Havant Thicket Reservoir

Statement of Community Involvement

Phase 4 – Southern Access Road

Document Reference: HTR-FUW-P4-SA-RP-W-1706

Option A – Dual-lane

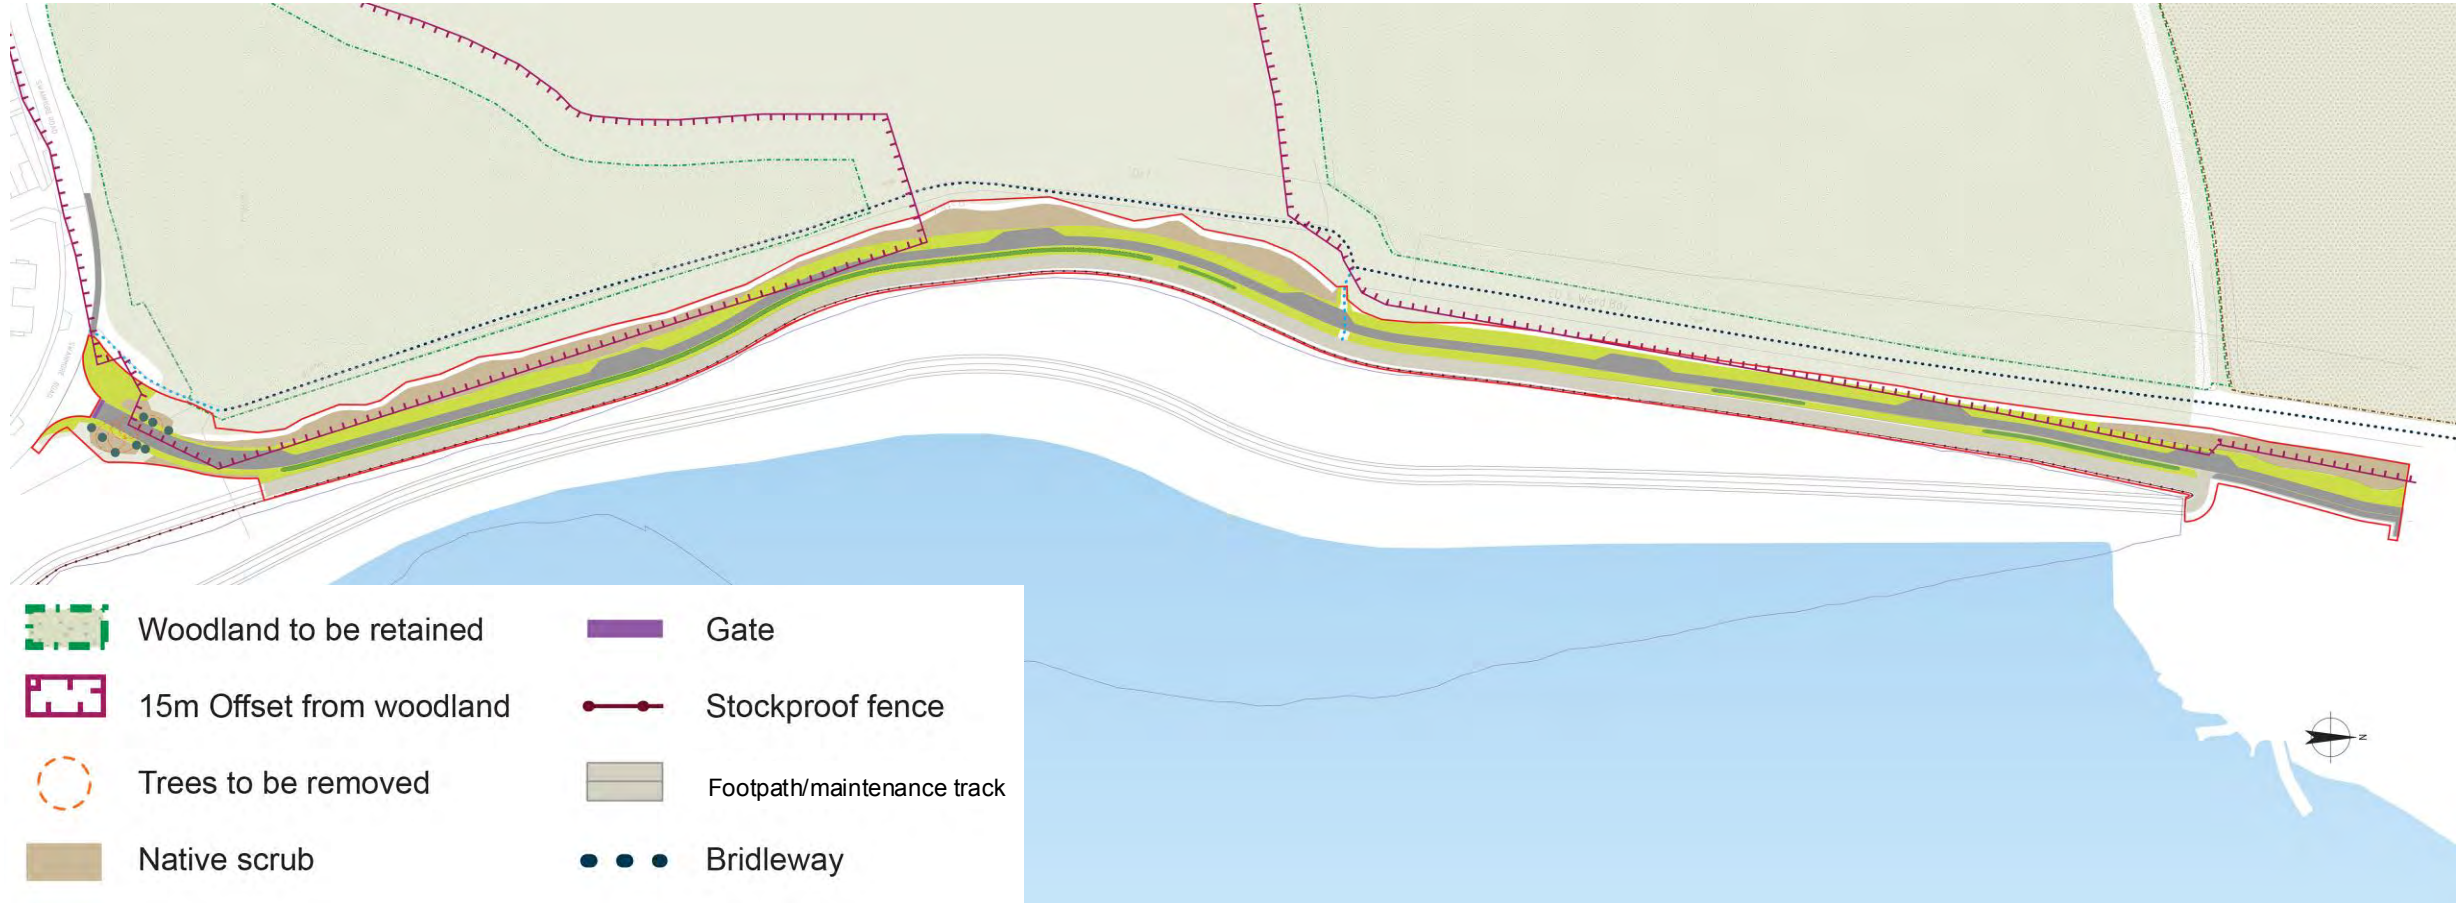
Questions/ suggestions (3)	Can it be dual road for less distance from Swanmore Road, as currently dual along distance in from junction. If dual for less there would be less impact on trees/ancient woodland.
	Disadvantages given on slide are exactly the same as a single lane northern access, so if ok for northern access, then must be ok for southern access to be single road.
	Emergency access could be along operational access road, if the single lane was blocked. (just need reinforced grass where hedge gap already is)

Ancient woodland (3)	Need to clarify the reference line for 15m measurements
	Need more clarity as to where the 15m AW offset is measured from? Should be starting to the east of the trees to east of the bridleway. Line should be shown clearly on the drawings where measurement is taken from.
	The 15m offset from the ancient woodland must be established as far as possible. Once the woodland is damaged it will not recover. We've lost too much ancient woodland to the reservoir already.
Wildlife corridor (5)	Re – Southern end of the Southern Access track – area 1. Good to see serious care being taken over the wildlife corridor. Please note that we have to allow for more than just dormice. Bats, birds, reptiles, amphibians, insects. Good to learn that sympathetic drainage features are planned.
	What will be the width of tree + vegetation wildlife corridor along length of Southern Access Road with: a) Single track? b) Dual track?

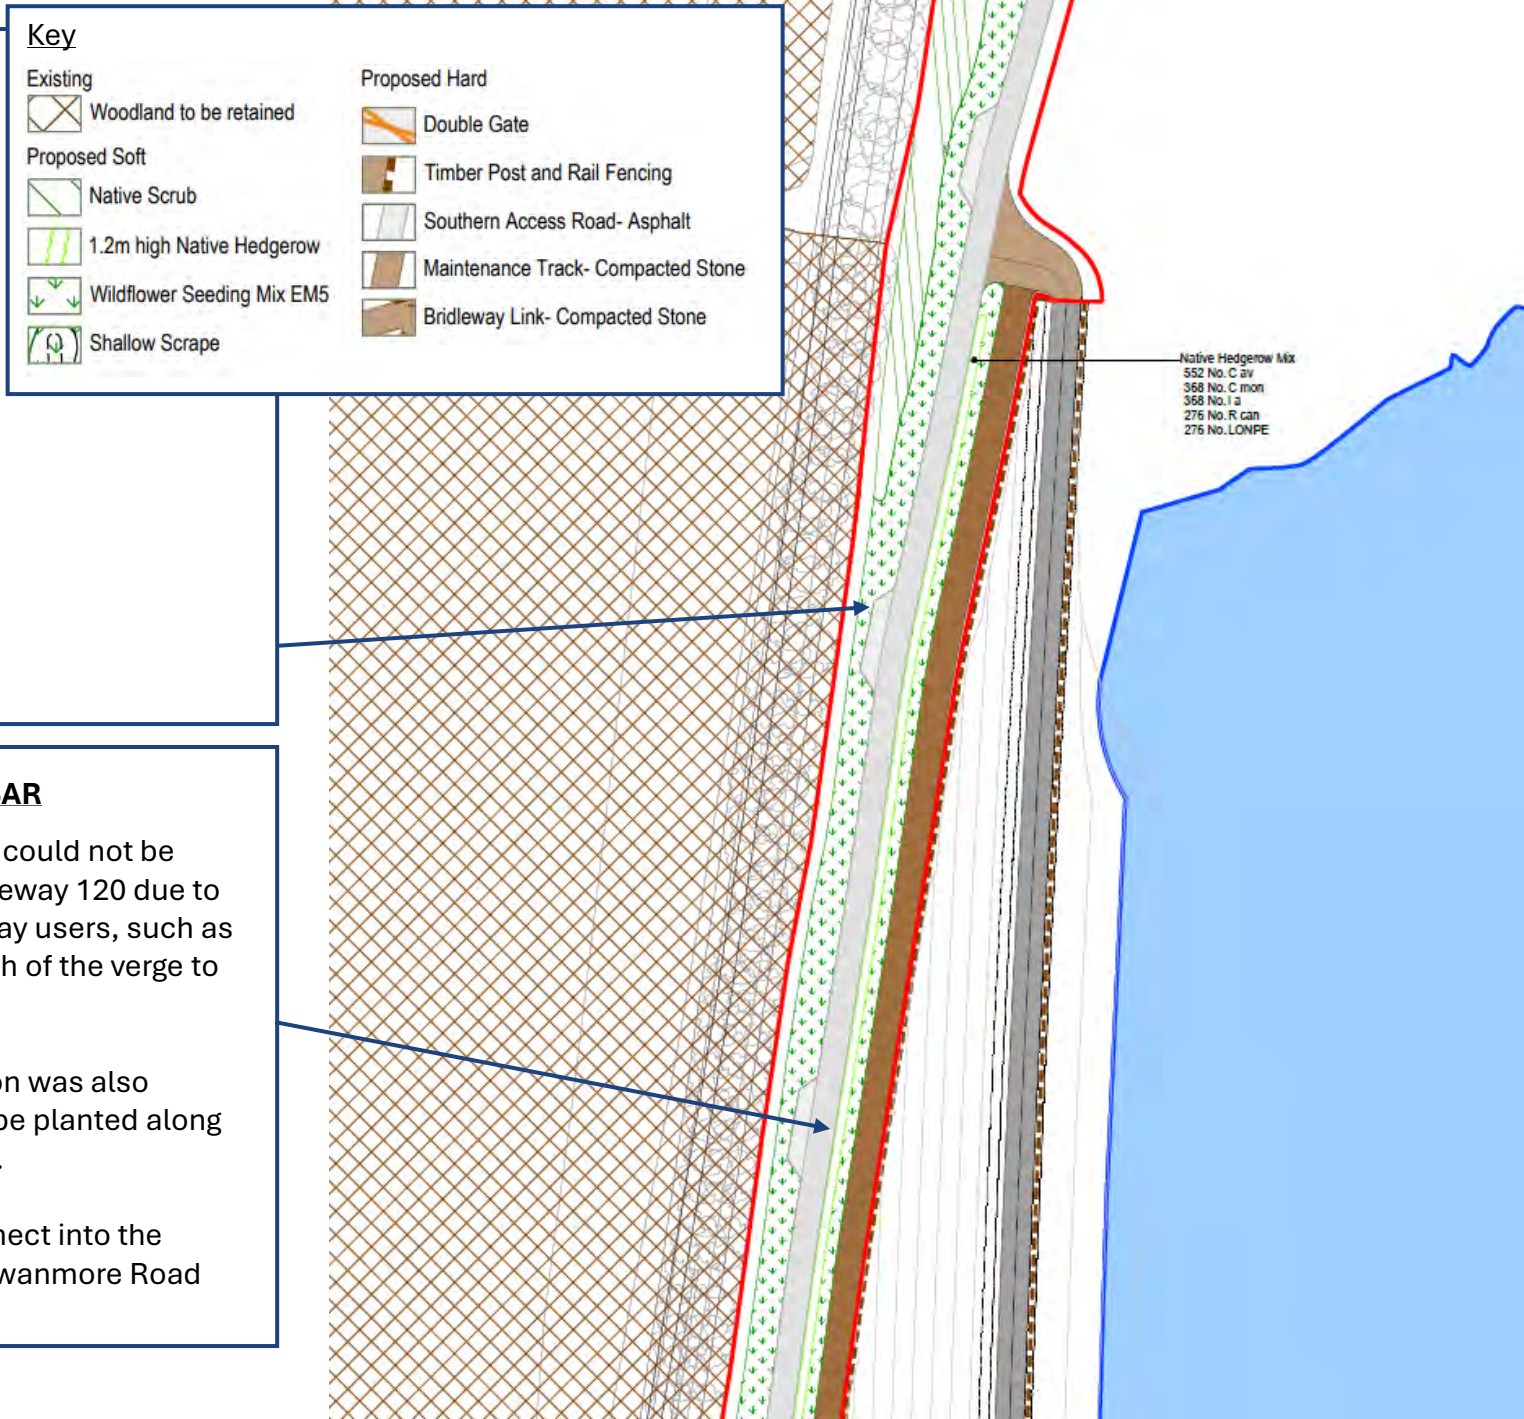
To support safe operation of the Southern Access Road and bridleway 120 as a single-lane road, the layout has been reviewed and amended slightly. This is to ensure that forward visibility and passing place spacing meet appropriate standards for a low-speed rural access route.

As a result, passing places are now provided at intervals of approximately 60m, reducing to 25m in the vicinity of the formal bridleway crossing to reflect the additional caution required at this location.

For bridleway crossing users, 66m visibility splays are provided for both approaches to each crossing. This is in line with Hampshire County Council’s TG3 guidance for equestrian crossings.

Increased connectivity at the wildlife corridor crossing

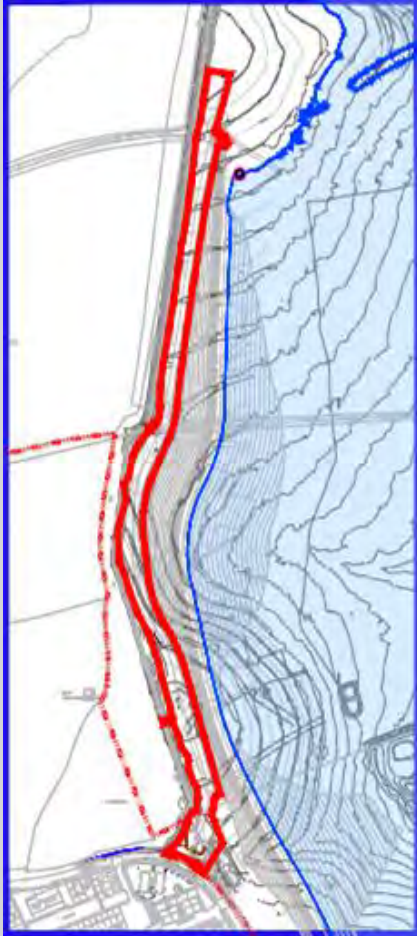
Following stakeholder feedback during the workshop session, landscaping at the Southern Access Road junction has been revised to incorporate additional planting and increased connectivity at the wildlife corridor crossing point.

Below is an indicative cross section of the wildlife crossing point just north of the access gate.

The touching canopies of the proposed tree planting enable movement across high ground, with understorey of native scrub for movement across open ground. In this location there are no kerbs or gully pots to allow animals such as dormice to cross without obstruction.
